UNITED STATES PATENT AND TRADEMARK OFFICE

APPLICATION NO.	FILING DATE	FIRST NAMED INVENTOR	ATTORNEY DOCKET NO.	CONFIRMATION NO.
10/821,860	04/12/2004	Federico Cabrele	713-1121	1818

Office Action Summary

DETAILED ACTION

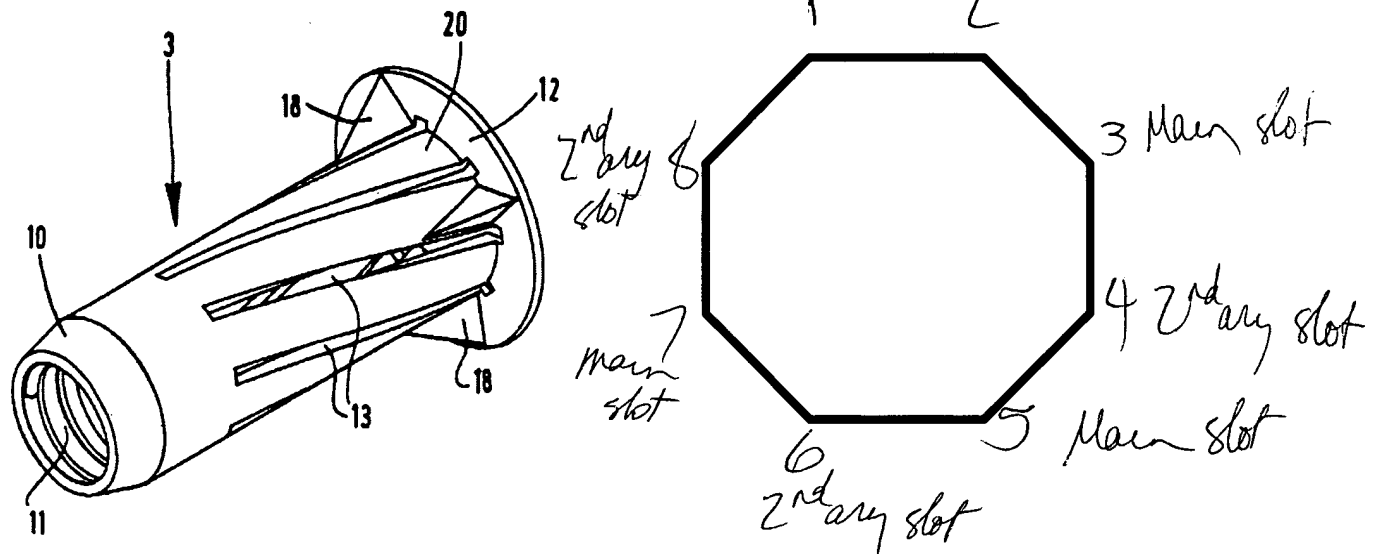
Re claim 1: Vernet shows a screw anchor (3) with a deformable (expandable - abstract) central portion in which 4 main longitudinal slots (13) are formed, and comprising a number of 2ndary longitudinal slots (13) formed in said central portion. Examiner notes that 4 slots (13) are considered main and the balance are considered secondary.

Re claim 3: Pairs of main longitudinal slots define main longitudinal anchoring tongues (strip between two "13's". It appears there are 8 equally-spaced slots "13" - examiner has labeled ^{an} ~~an~~ octagon below which are considered main and which are considered secondary.

Re claims 8-9: referring to the numbering by examiner of the octagonal shape, representing the collar with 8 slots of Vernet, slots 1&6, 2&5, 3&8, and 4 & 7 face and are coplanar, and assuming ^{1, 3, 5 and 7} 1 and 7 are "the adjacent" main slots,

Re claims 10-12: a head with a collar at a first end, said collar with annular flange (12) coaxial with longitudinal axis as shown in Fig 5 above. Projecting appendices (18) are shown as equally spaced and integral with collar and parallel to longitudinal axis. There is a head (10) at opposite end.
